Subject: Callaway Plant, Unit 1 - Amendment No. 3 to License NPF-30

AMENDMENT TO FACILITY OPERATING LICENSE

Amendment No. 3
License No. NPF-30

SAFETY EVALUATION BY THE OFFICE OF NUCLEAR REACTOR REGULATION
SUPPORTING AMENDMENT NO. 3 TO FACILITY OPERATING LICENSE NO. NPF-30

FIGURE 6.2-2

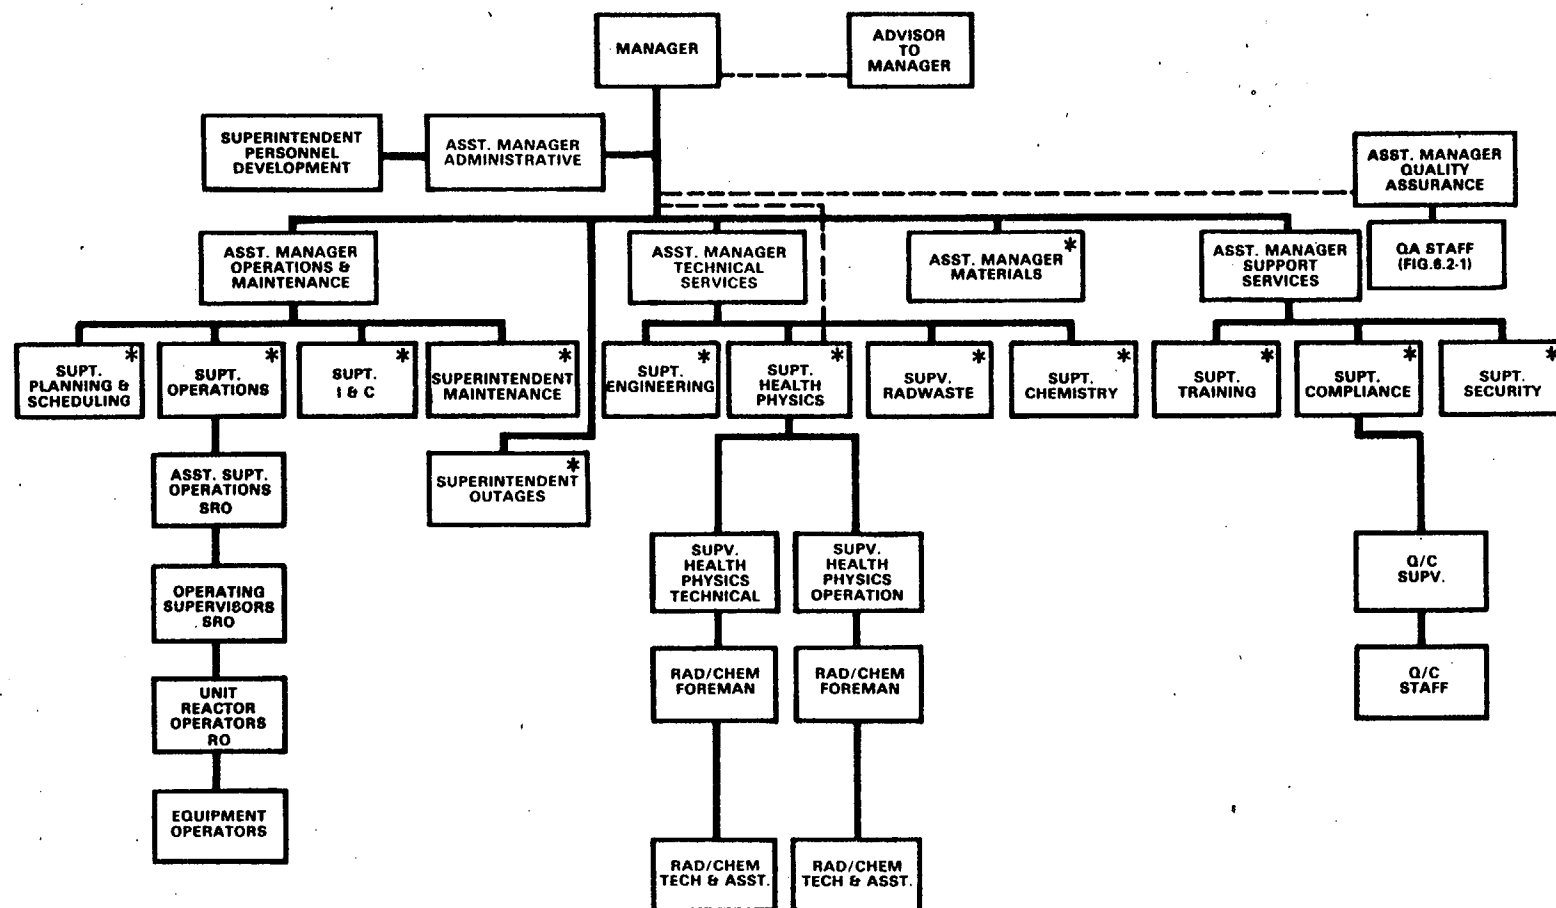
The amendment approves a modification to Figure 6.2-2 of the Callaway Technical Specifications consisting of the addition of two managerial positions to the plant organization. The amendment also approves a modification to Section 6.5.1.2 consisting of the addition of another member to the On-Site Review Committee.

The licensee has created two new managerial positions, entitled "Assistant Manager, Administrative" and "Superintendent, Outages," both reporting to the Manager, Callaway Plant. The former is responsible for certain administrative and personnel matters. The latter is responsible for all aspects of outage planning and scheduling. The licensee's intent is to enhance plant operations by segregating general administration and outage planning as separate segments of the plant organization, thereby allowing the operating departments to concentrate on their primary responsibilities.

The staff concludes that the organization changes described above are primarily administrative and do not decrease the scope or number of plant functions and responsibilities. The staff concurs that the reassignment of general administrative and outage planning duties as separate and segregated responsibilities should enhance plant operations.

Based on the above, we conclude that the licensee's proposal to change the Unit Organization and the composition of the On-Site Review Committee is acceptable.
